Driveline Guard – Missing Brace on A3FE and BBCV Units Service Notice #18-1109REVA

Missing Brace May Cause Driveline to Contact Air Brake Components on A3FE and BBCV Units

Figure #1

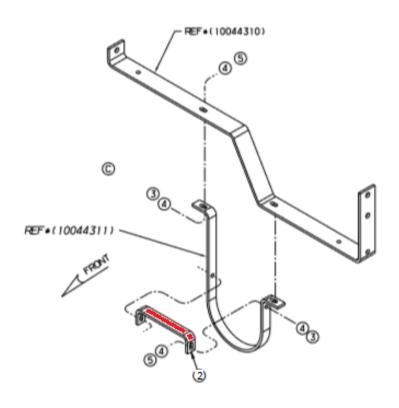
We have found that with a specific driveline guard configuration that a crossbrace was left off. Without this brace there is the possibility that the driveline could contact an air tank and air lines should the driveline break free.

The guard in question is shown in Figure #1 and is a "mid-mount" guard which is generally mounted to protect the center section of the driveline near the air tanks as in Figures #2 & #3.

Generally we have found that most units have the holes predrilled in the "loop" for the cross-brace and installing is a matter of bolting the brace (shown in red in Figure #1) and torqueing the bolts to 29-33 ft/lbs.

We are asking that customers inspect their units to ensure the bracket is in place, if it is not please contact New York Bus Sales and we will provide the part at N/C.

Figure #4

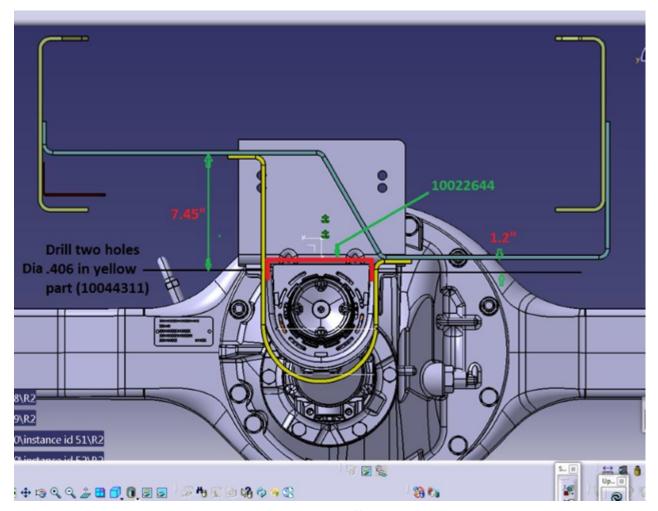
There is an added photo showing the brace placement in Figure #4 should holes need to be drilled.

BRACE PART #10022644

Figure #5

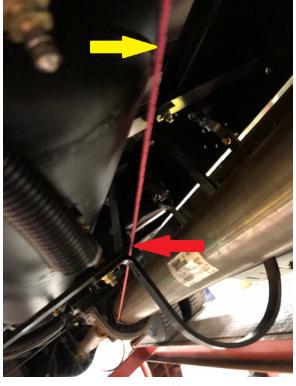
#1 – Obtain a string and using a tape of some sort secure the string to the driveline section in question at the rear mount. (Figure #5)

#2 – Pull the string forward through the driveline guard and straight up toward the front of the vehicle and check to see if it contacts the air tank, fittings or lines. Figure #6 shows the string touching the air tank (Yellow Arrow) while it is still a slight distance away from the guard (Red Arrow). This indicates the brace is needed.

Figure #7

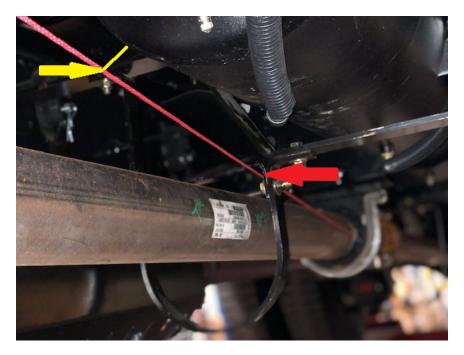
#3 – Once the brace is added as in Figure #7, you can see that the string is a distance away from the air tank which indicates that should the driveline fail, the guard would protect the air tank. As you can also see in the figure, the brace is fairly close to the driveline. In this instance it is at the minimal $\frac{1}{2}$ spacing.

These are from a 65 passenger unit with a 252" wheelbase and as stated when used on a longer or shorter wheelbase there maybe a difference in the brace

Figure #8

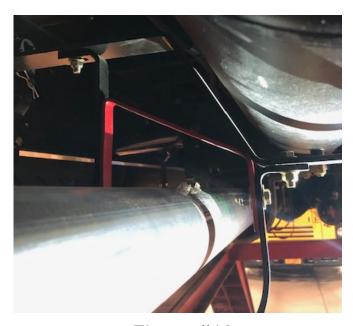
Figure #8 shows a brace that New York Bus Sales makes should the Blue Bird brace not work due to the driveline being too high in the guard. This brace is also NOT drilled so that correct placement can be made.

EXTENDED BRACKET PART #NYB-085
